February 4, 2020

Re: Environmental Assessment Certificate (EAC) #E14-02: Schedule A (Project Description) & Design of Highway 29 Crossings at Farrell Creek, Dry Creek and Lynx Creek – Proposed Amendments

The purpose of this letter is to seek amendments to Section 4.3.4.1 (Table 4.5) in Schedule A of the Project's Environmental Assessment Certificate #E14-02 ("EAC"). These amendments relate to changes in the design of the Highway 29 crossings for Farrell Creek, Dry Creek and Lynx Creek which have been made based on information obtained through geotechnical investigations and stability analyses. Specifically, BC Hydro proposes that:

Figure 3: General arrangement of Highway 29 realignment segment at Dry Creek, per proposed revised bridge design (proposed Figure 4.29 Rev 1)

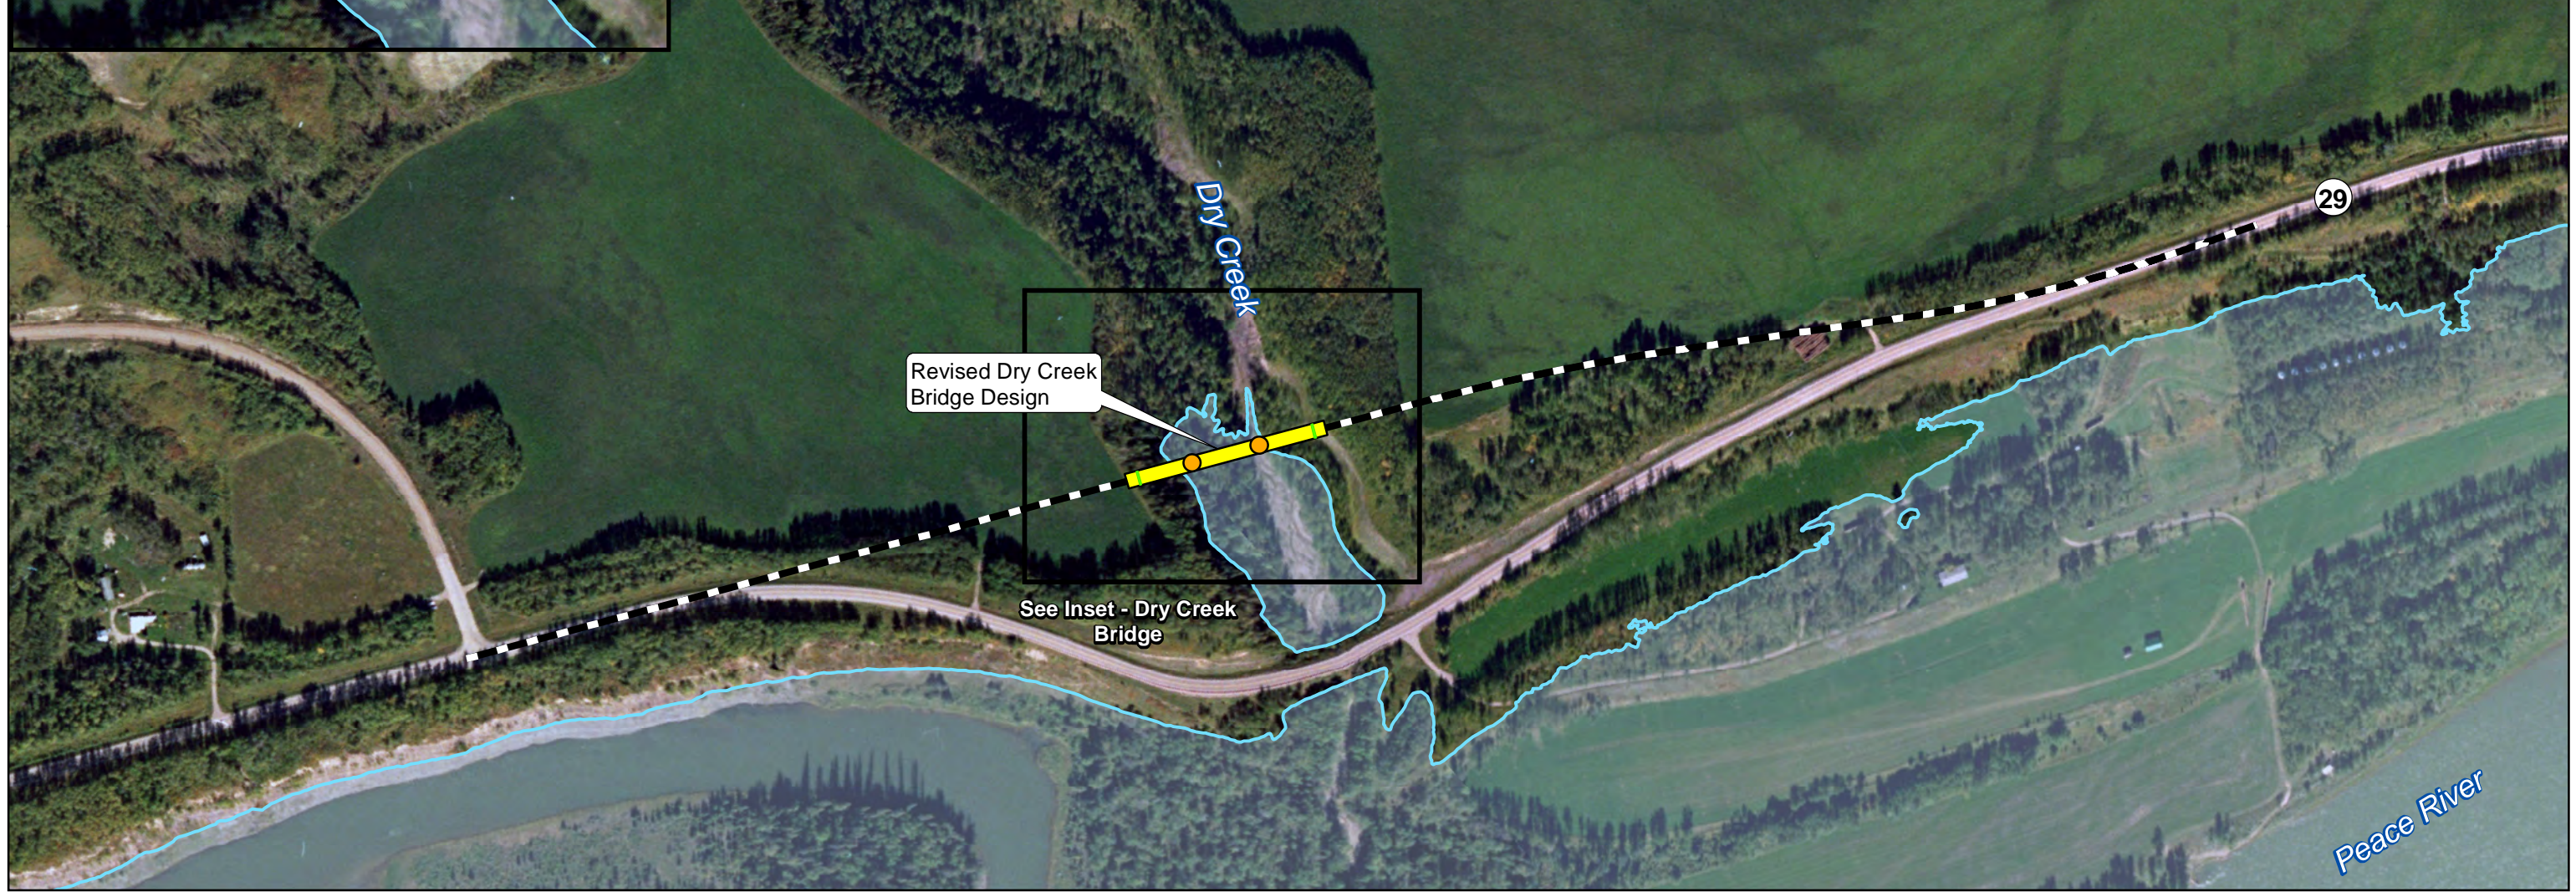
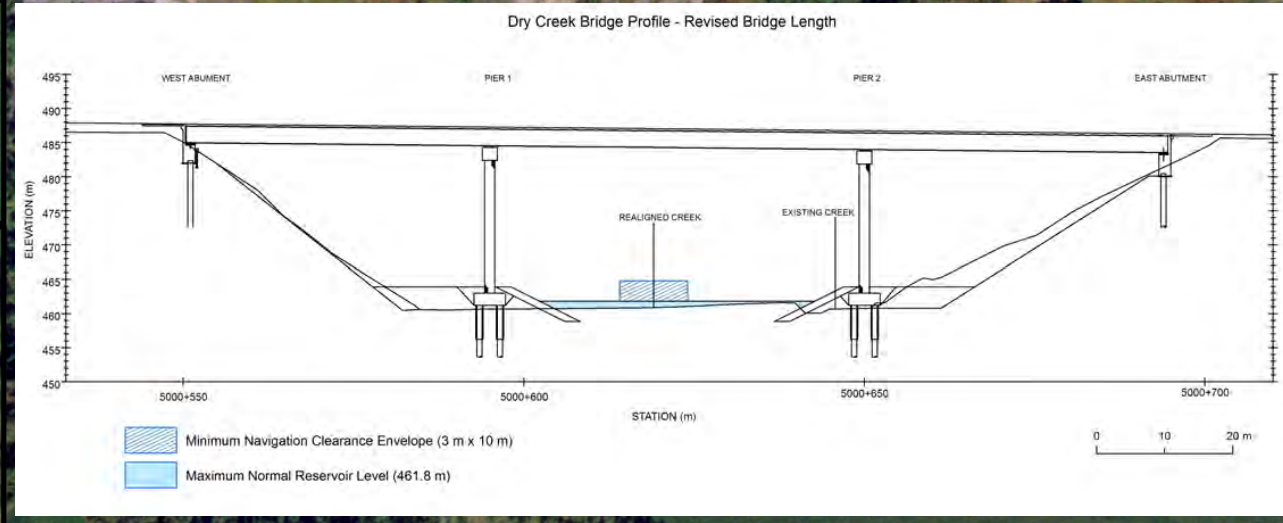
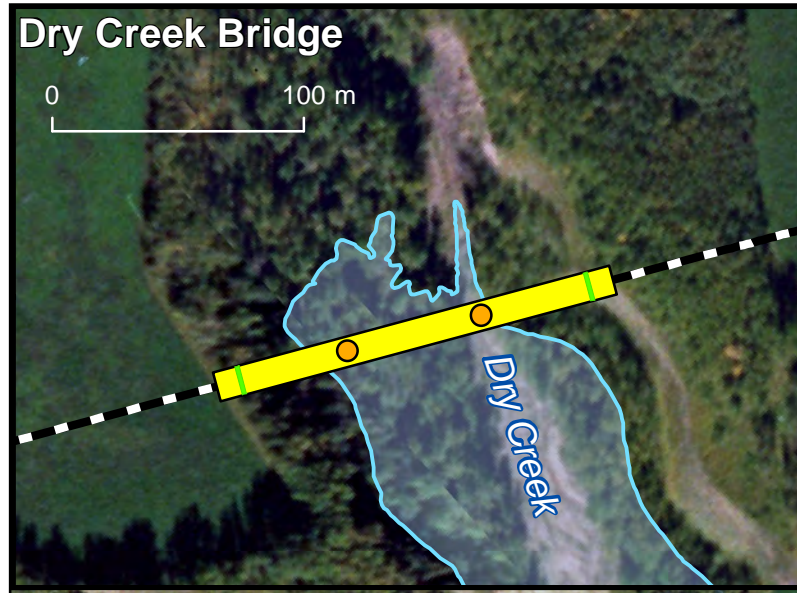
- a long bridge design replace the causeway and short bridge design currently approved for Farrell Creek
- a bridge replace the culvert currently approved for Dry Creek, and
- a same length causeway and longer bridge replace the causeway and bridge currently approved for Lynx Creek

Component	Text from EAC Schedule A Project Description	Requested Amendments to Schedule A Project Description
Highway 29 Realignment Dry Creek	Section 4.3.4.1, Table 4.5: Highway 29 Realignment Segments and Respective Watercourse Crossing Lengths For Dry Creek: Total Length of Segment: 1.5 km Causeway Length: N/A* Bridge Length: 11 m pipe-arch culvert Number of Piers: N/A Number of Bridge Spans: N/A Figure Number: Figure 4.29 Rev 0 (attached as Appendix B, Figure 2)	Section 4.3.4.1, Table 4.5: Highway 29 Realignment Segments and Respective Watercourse Crossing Lengths For Dry Creek: Total Length of Segment: 1.5 km Causeway Length: 0 m Bridge Length: up to 200 m Number of Piers: up to 3 Number of Bridge Spans: up to 4 Figure Number: Figure 4.29 Rev 1 (attached as Appendix B, Figure 3)

Figure 4: Profile of Dry Creek Crossing, per EAC Schedule A Design (not to scale)

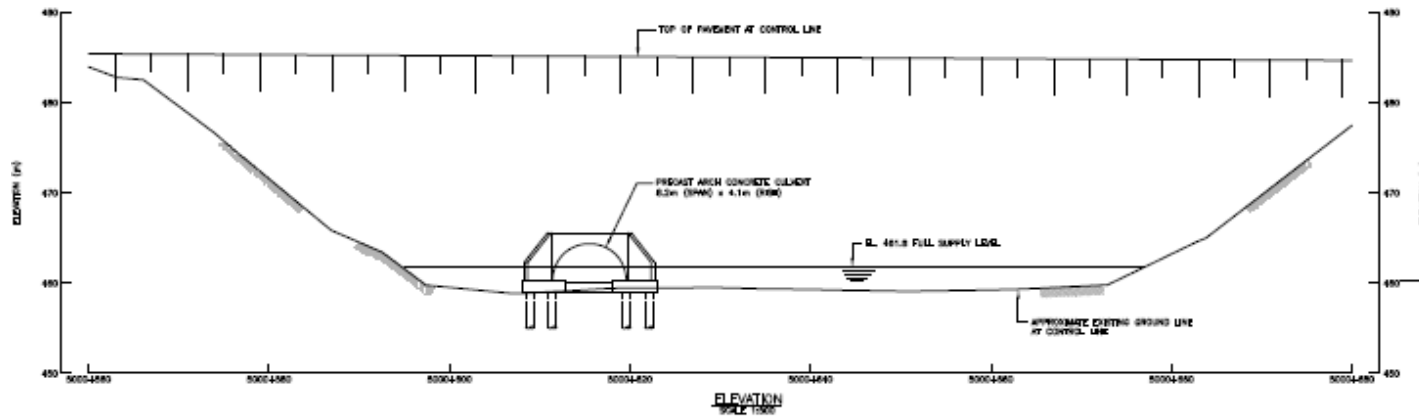
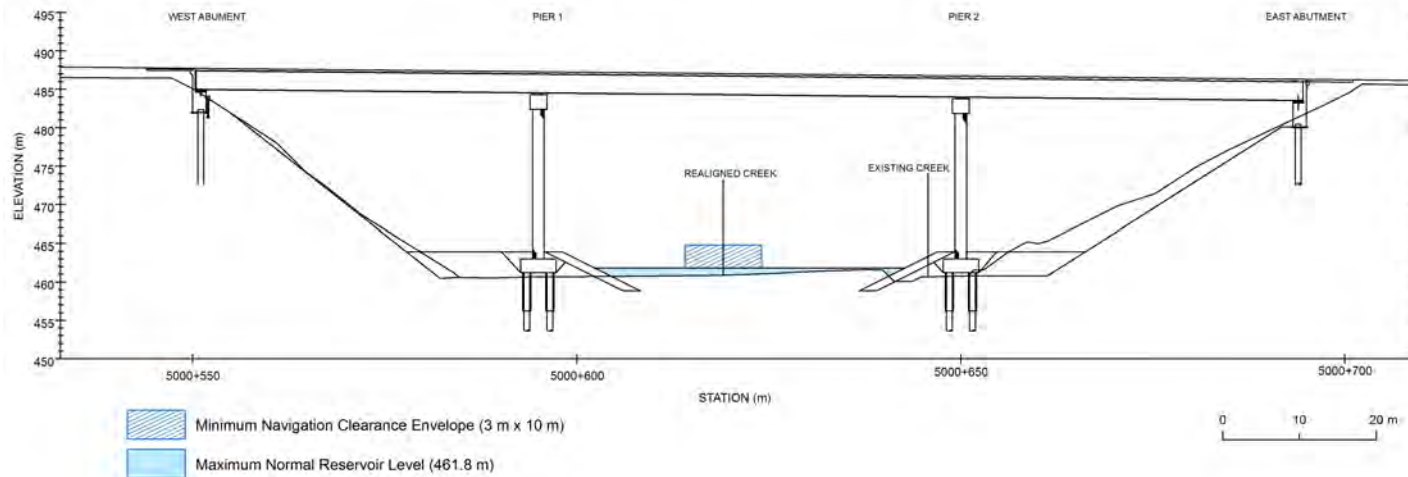
The assessment is supported by information in Figures 4 and 5 – the EAC Culvert and Revised Design Bridge profiles -- and Figure 6, a plan view of the EAC Schedule A culvert design versus the proposed revised bridge design, post reservoir filling.

Figure 3: General arrangement of Highway 29 realignment segment at Lynx Creek, per proposed revised bridge design (proposed Figure 4.28 Rev 1)

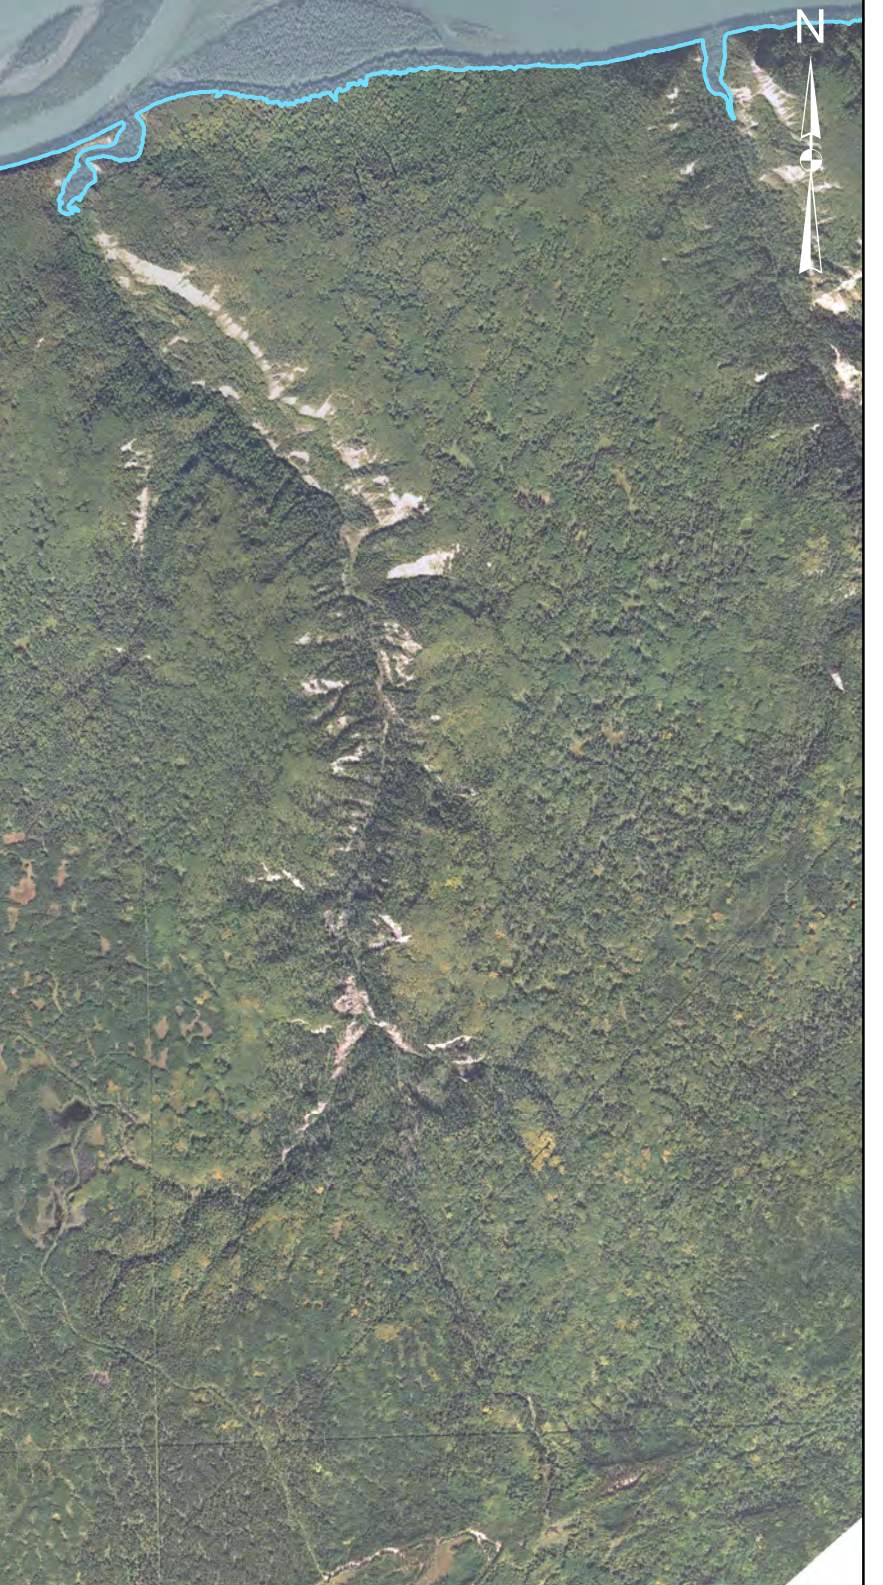
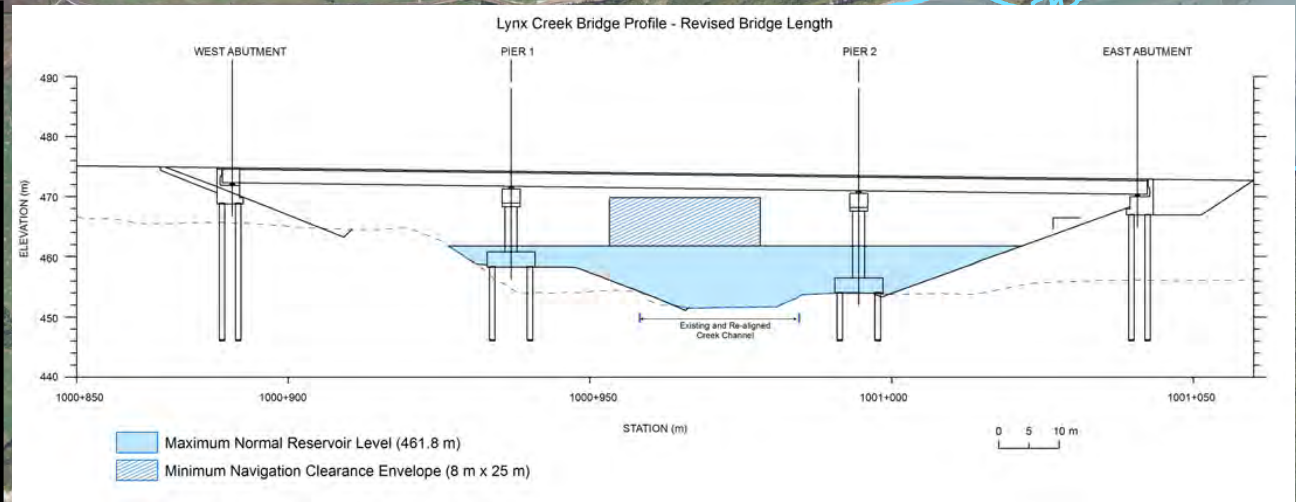
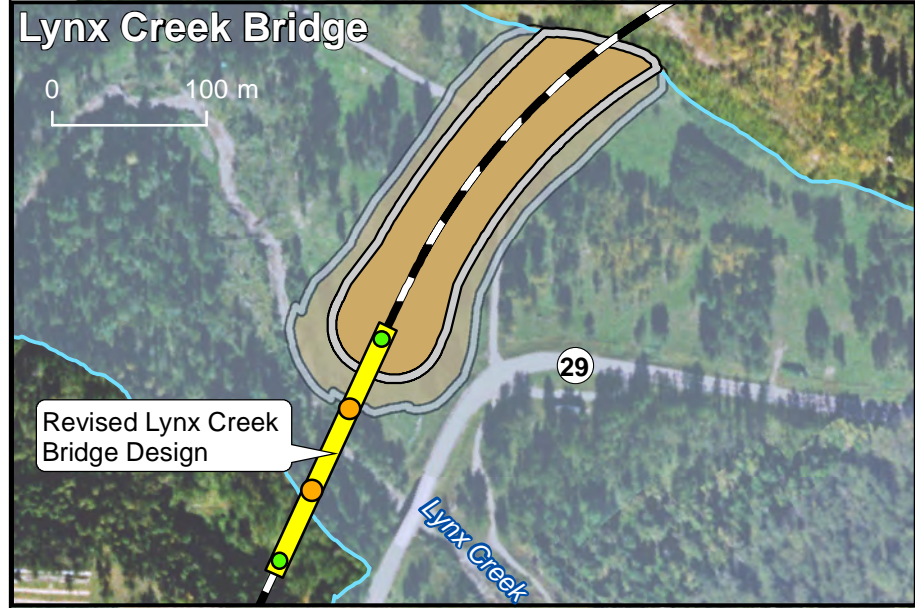
- **Lynx Creek Crossing:** Refinements to the causeway and bridge lengths at the Lynx Creek Crossing were made through the design process to minimize elevation changes between the east and west approaches. The proposed revised causeway will remain the same length, and the bridge length will be up to 20m longer than the EAC design. These changes are required to

As shown in Figures 2, 3 and 6, the proposed design changes to the Lynx Creek crossing will not materially change the alignment of the crossing, with the proposed revised alignment a few degrees offset from the EAC approved alignment. The height of the causeway for the proposed revised crossing has been lowered, resulting in a design requiring additional excavation within the vicinity of the crossing. This excavation will take place within the area of disturbance as assessed for the EAC. In addition, this excavation would be used in the causeway construction, thereby reducing the need to haul material from external sources for construction.

Component	Text from EAC Schedule A Project Description	Requested Amendments to Schedule A Project Description
Highway 29 Realignment Lynx Creek	Section 4.3.4.1, Table 4.5: Highway 29 Realignment Segments and Respective Watercourse Crossing Lengths For Lynx Creek: Total Length of Segment: 8.0 km Causeway Length: 290 m Bridge Length: 160 m Number of Piers: 1 Number of Bridge Spans: 2 Figure Number: Figure 4.28 Rev 0 (attached as Appendix C, Figure 2)	Section 4.3.4.1, Table 4.5: Highway 29 Realignment Segments and Respective Watercourse Crossing Lengths For Lynx Creek: Total Length of Segment: 8.0 km Causeway Length: up to 290 m Bridge Length: up to 180 m Number of Piers: up to 3 Number of Bridge Spans: up to 4 Figure Number: Figure 4.28 Rev 1 (attached as Appendix C, Figure 3)

Figure 4: Profile of Lynx Creek Bridge, per EAC Schedule A Design (not to scale)

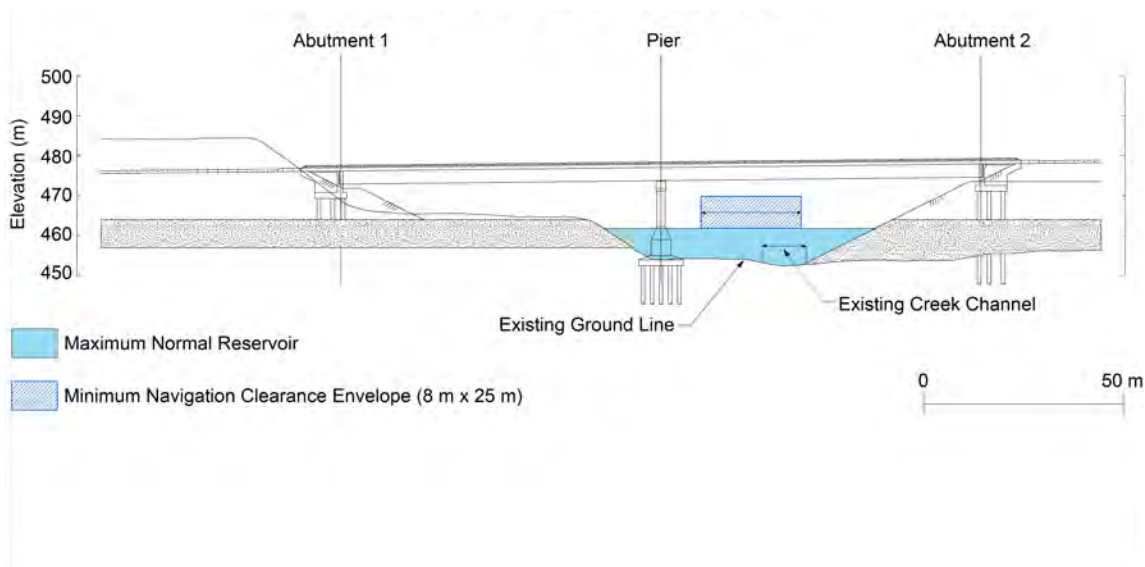
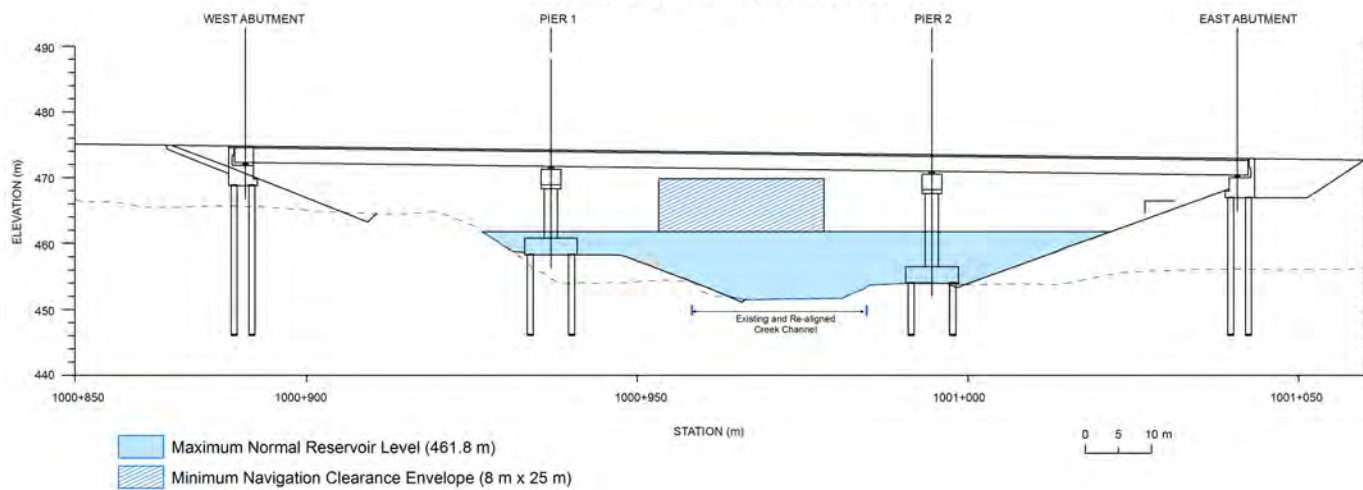
The assessment is supported by information in Figures 4 and 5 – the EAC and Revised Design bridge profiles -- and Figure 6, a plan view of the EAC Schedule A bridge design versus the proposed revised design, post reservoir filling.
